Access Compliance Report

Public Rights-of-Way

(Curb Ramps)

Intersection ID: 50601	Main Street: LUSTERLEAF_HOLLY_RD	Cross Street: HEARTLEAF_RD	Location: SE
ADA ID: E5085F56B33B	Ramp Type: BlendTrans1	Initial Pass/Fail: Pass	Overall Compliance: No
		Severity Score: 5	
Codes/Mitigation Info/Possible Solution		Field Measurements/Component Compliance

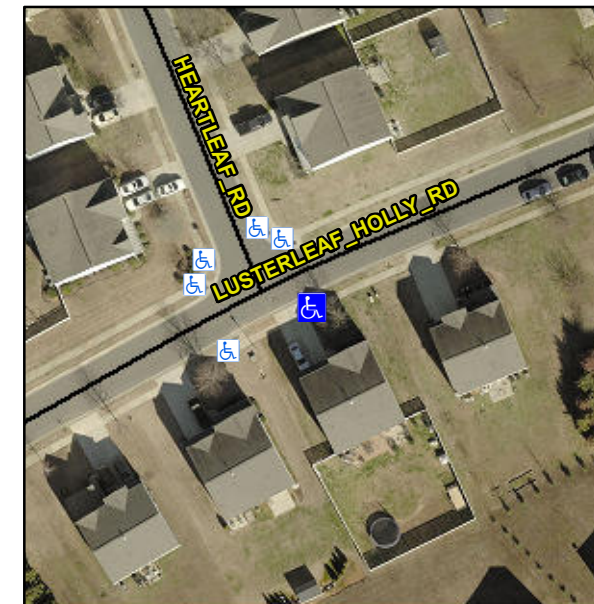
CURB LIP 0.5

Not Found, R304.2.1, R305.2, R304.5.4

Remove & Replace Curb Ramp With Two New Directional Ramps or Equivalent. Remove & Replace Gutter.
